SANITARY AND STORM SEWER LINES TO SERVE HENTZEN ADDITION

1298 PPS (607861)
CITY OF WICHITA, KANSAS
Neil D. Cable, P.E., City Engineer

AS-BUILT
1-13-04
Date
Brenda Bohlen
Signat

APPROVED AS NOTED

Hentzen Addition
Sanitary Sewer Line 1
Wichita, Ks

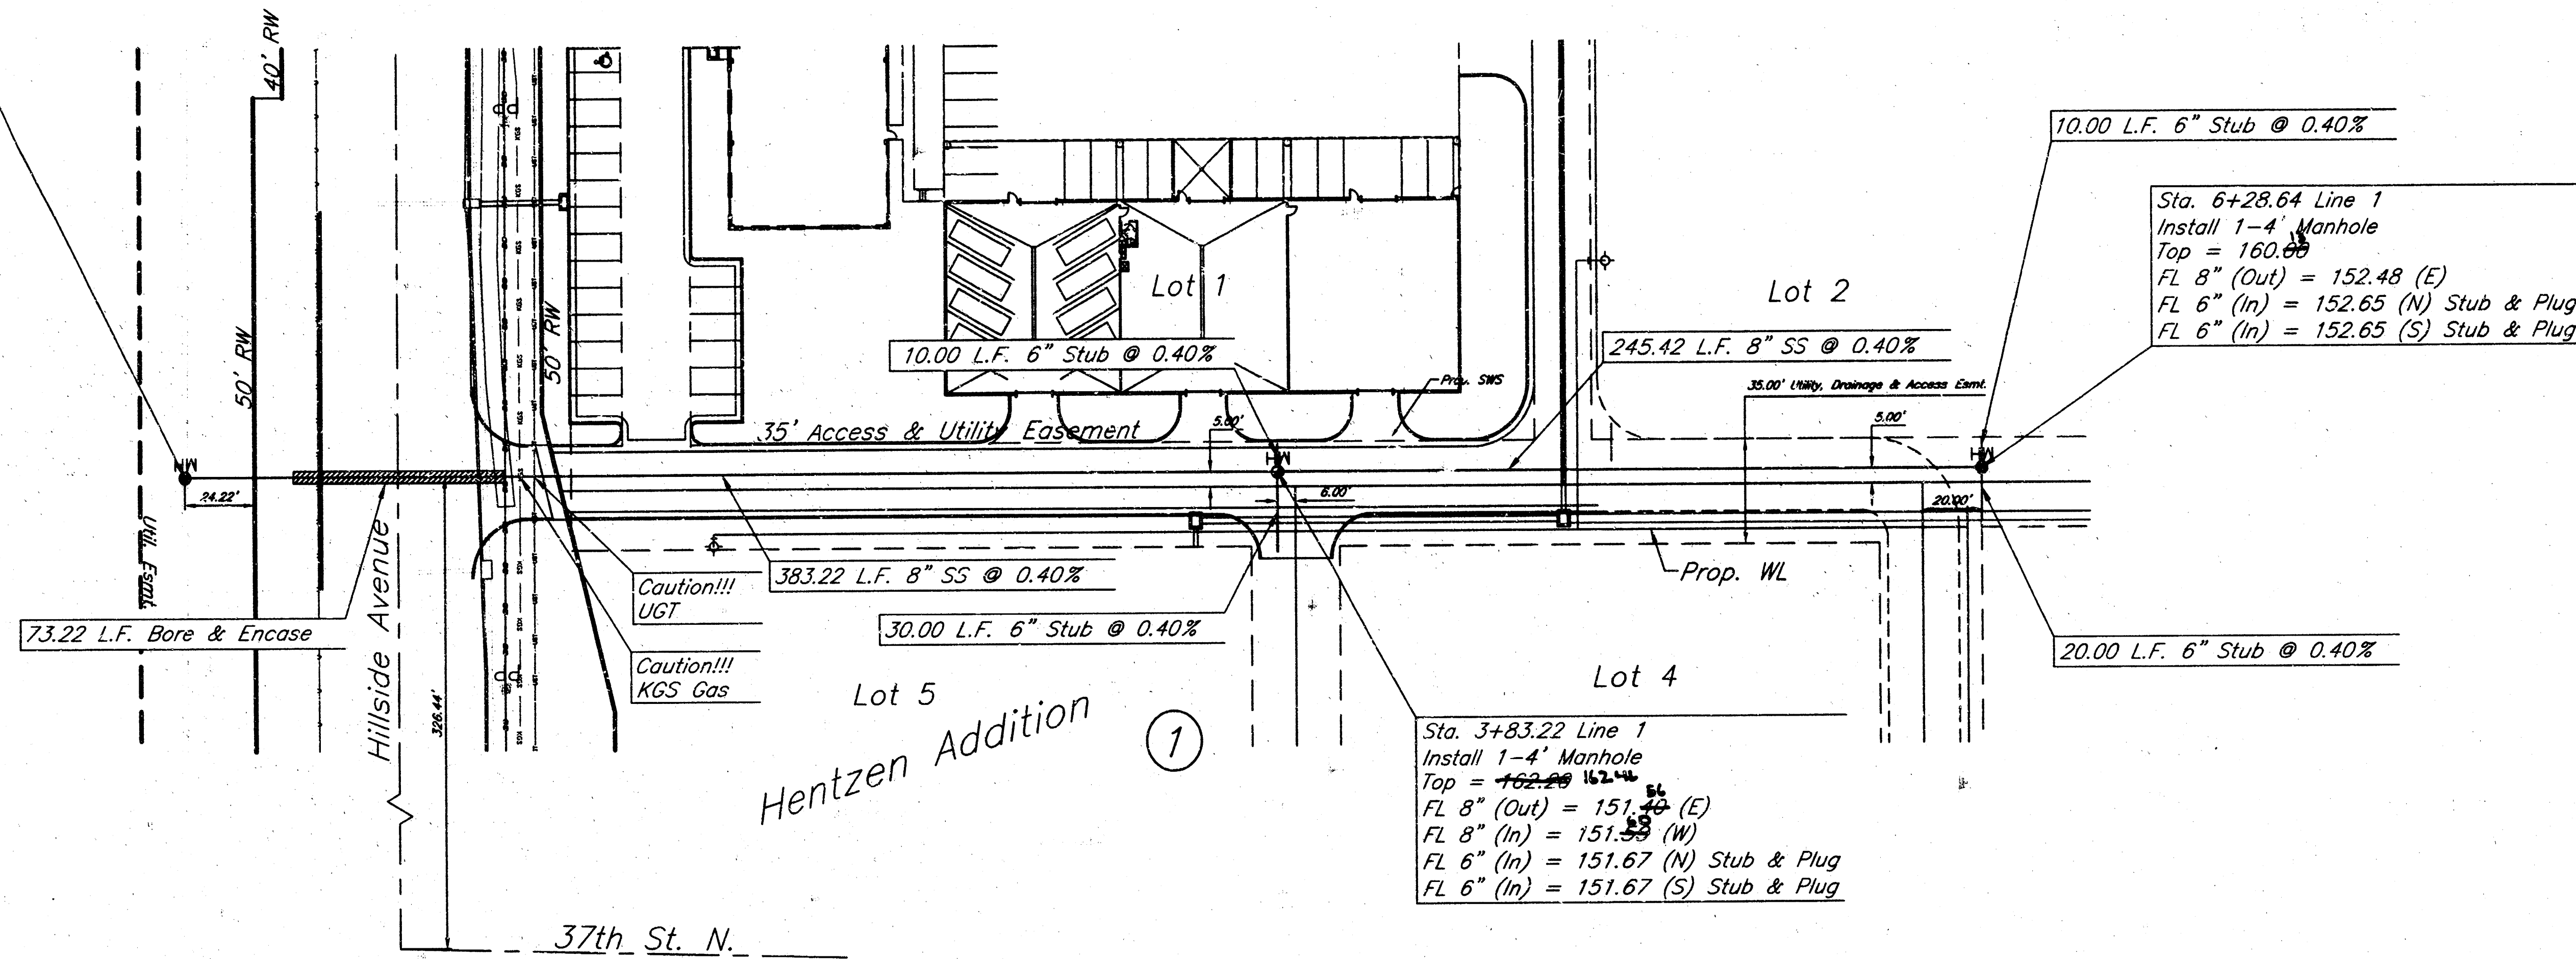
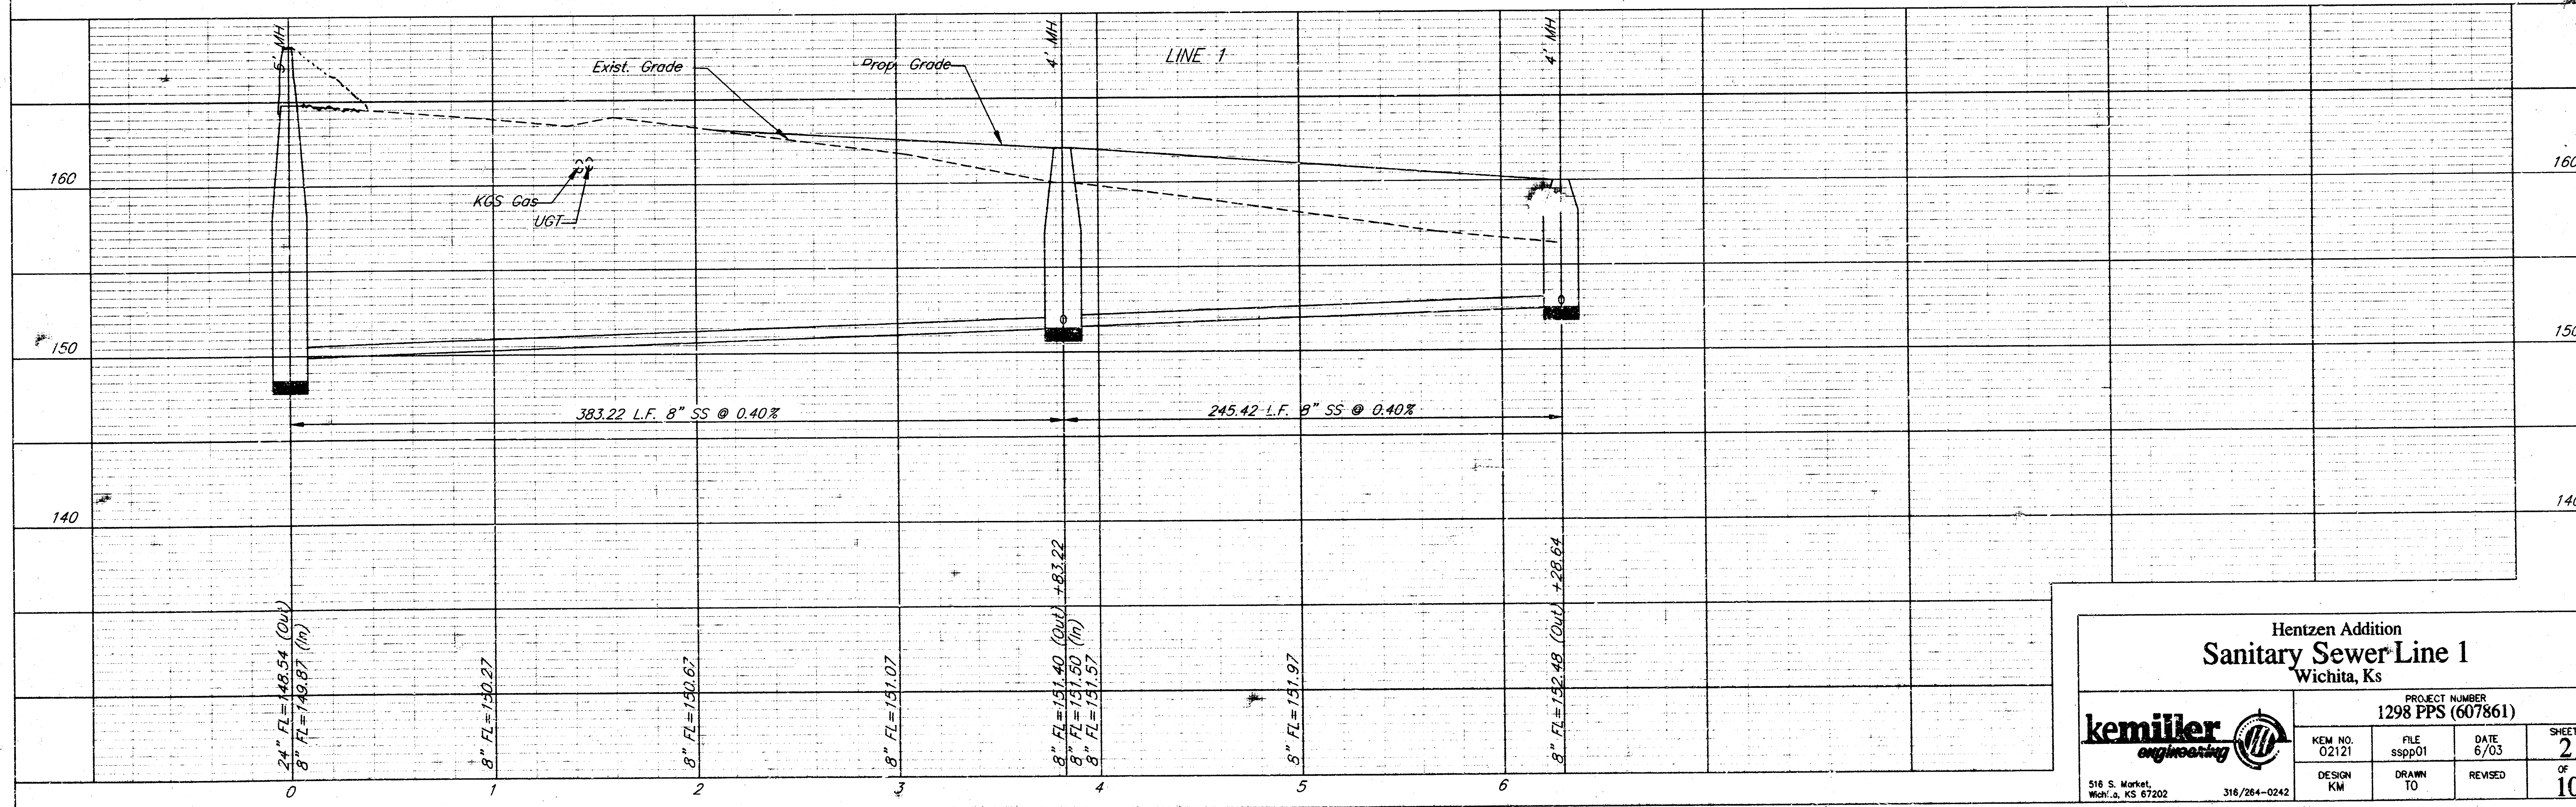
Sta. 0+00 Line 1
Install 1-5' Manhole
over Existing 24" SS Line
Top = ~~148.89~~ 148.24
FL 18" (Out) = 148.44 (S)
FL 18" (In) = 148.54 (N)
FL 8" (In) = 149.87 (W)

Sta. 3+83.22 Line 1
Install 1-4' Manhole
Top = ~~152.25~~ 152.40
FL 8" (Out) = 151.40 (E)
FL 8" (In) = 151.50 (W)
FL 6" (In) = 151.67 (N) Stub & Plug
FL 6" (In) = 151.67 (S) Stub & Plug

**Hentzen Addition
Storm Sewer Line 1
Wichita, KS**

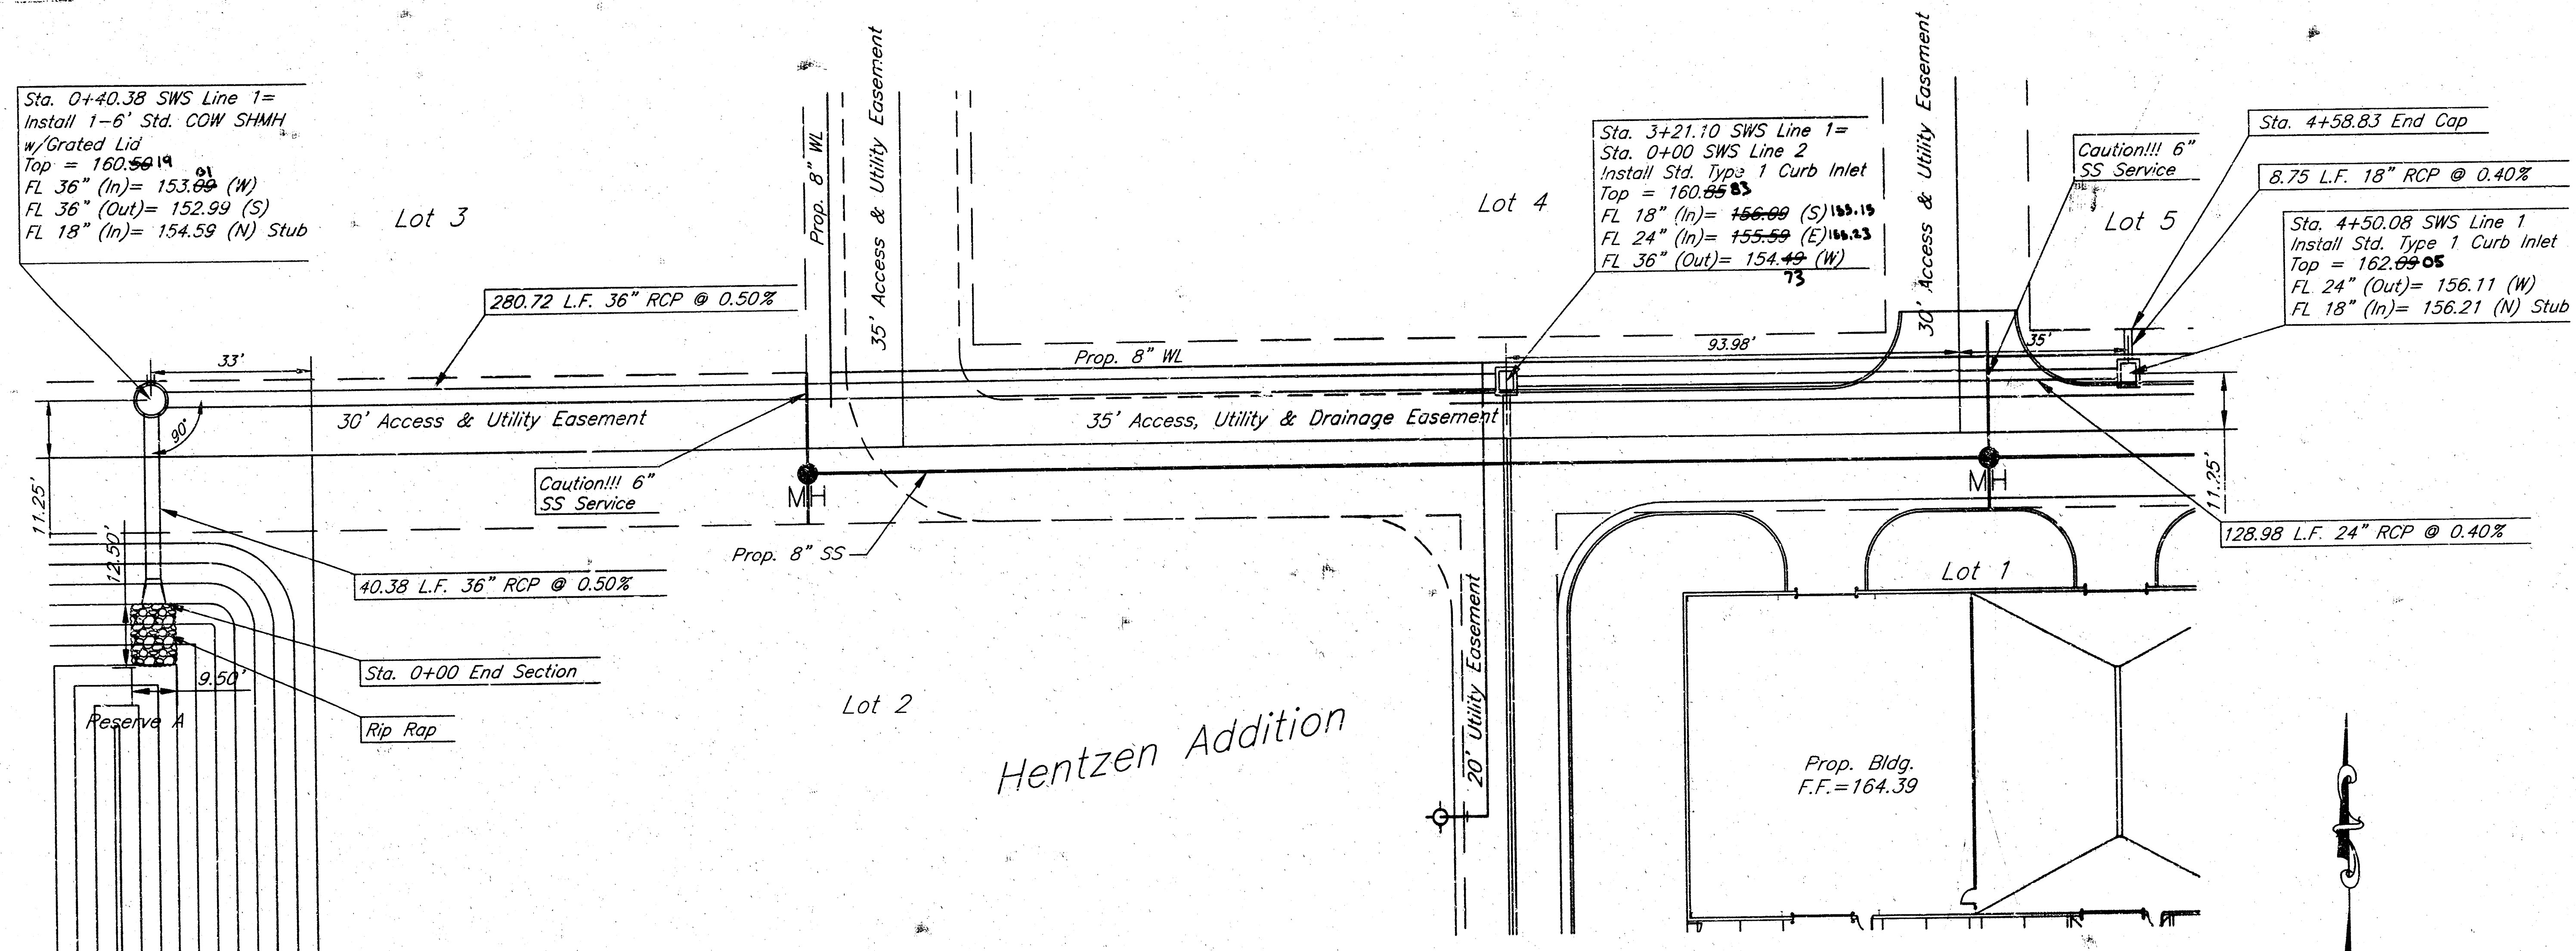
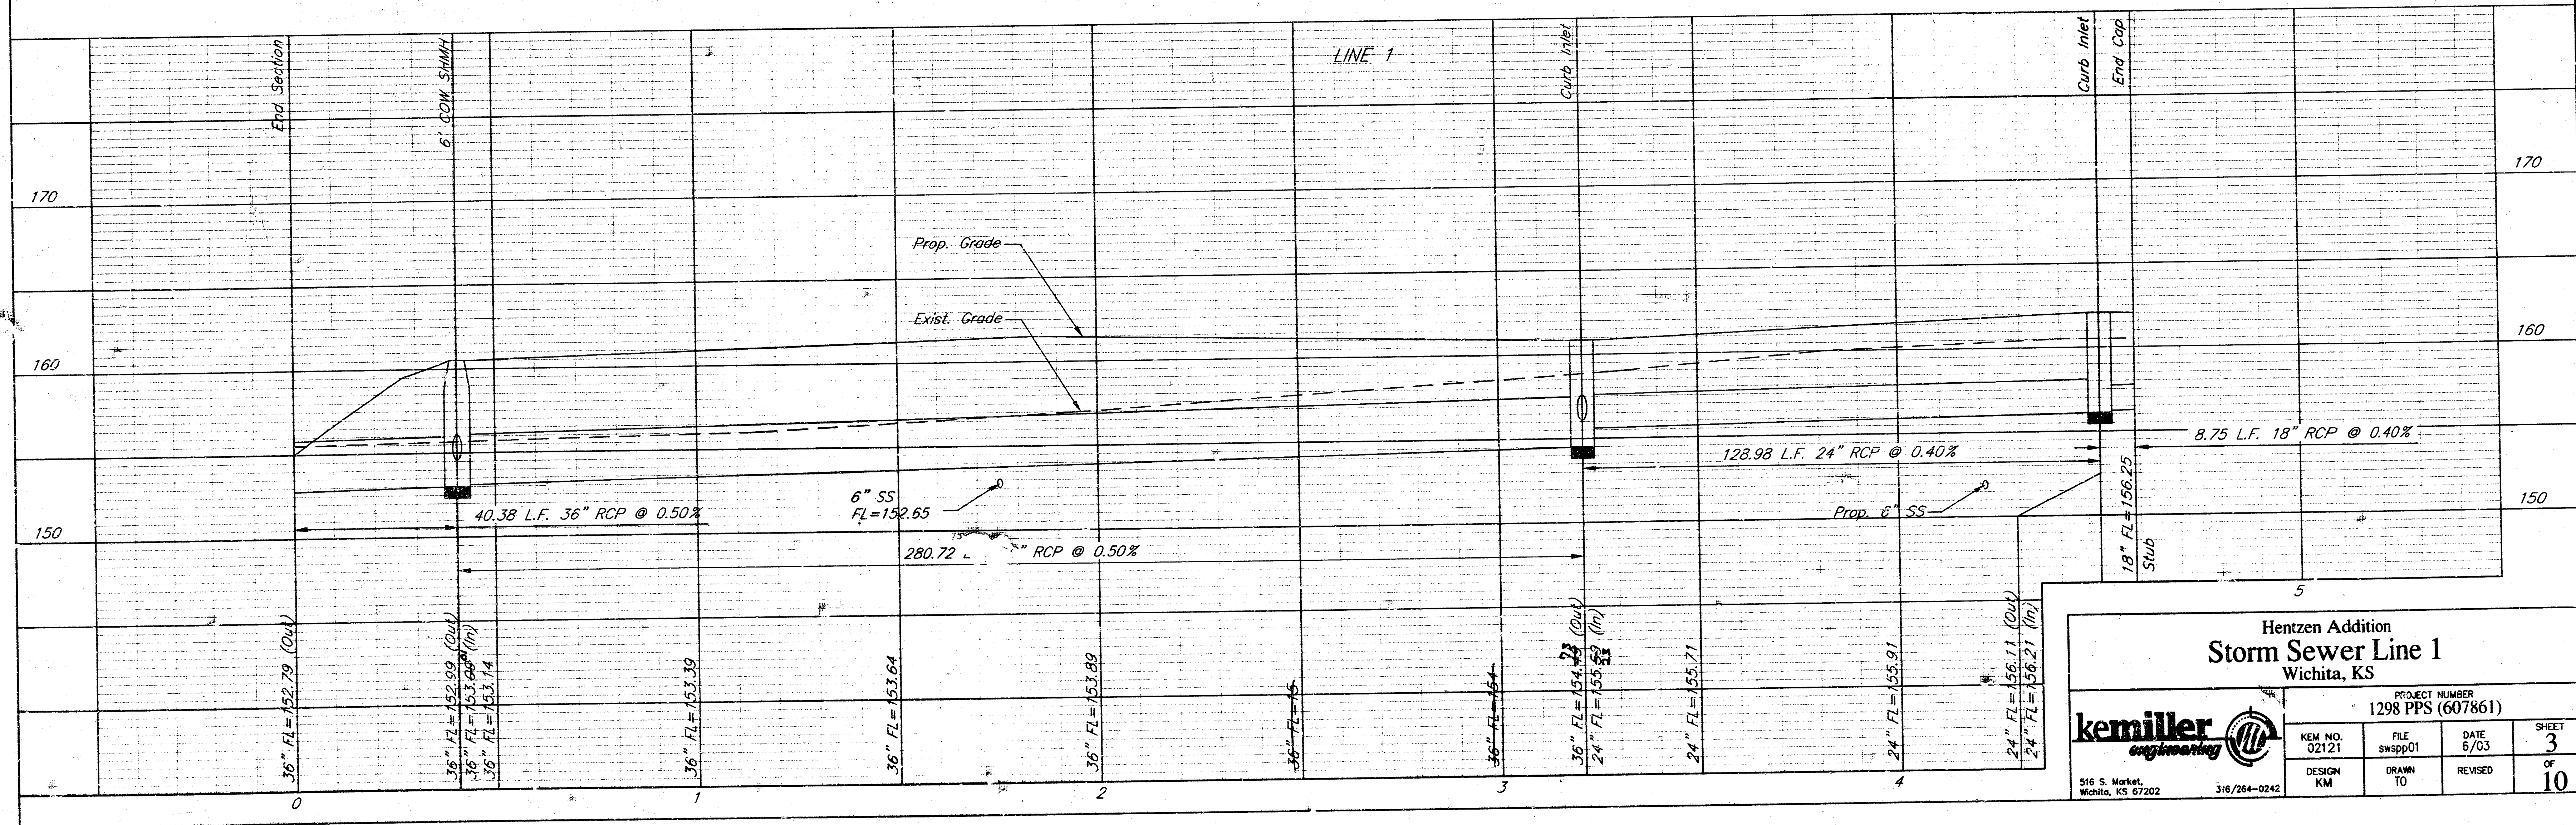
Sta. 0+40.38 SWS Line 1=
Install 1-6' Std. COW SHMH
w/Grated Lid
Top = 160.5019
FL 36" (In)= 153.64 (W)
FL 36" (Out)= 152.99 (S)
FL 18" (In)= 154.59 (N) Stub

Sta. 3+21.10 SWS Line 1=
Sta. 0+00 SWS Line 2
Install Std. Type 1 Curb Inlet
Top = 160.6583
FL 18" (In)= 156.00 (S) 155.15
FL 24" (In)= 155.55 (E) 154.43
FL 36" (Out)= 154.45 (W)

Sta. 4+58.83 End Cap
8.75 L.F. 18" RCP @ 0.40%
Sta. 4+50.08 SWS Line 1
Install Std. Type 1 Curb Inlet
Top = 162.0505
FL 24" (Out)= 156.11 (W)
FL 18" (In)= 156.21 (N) Stub
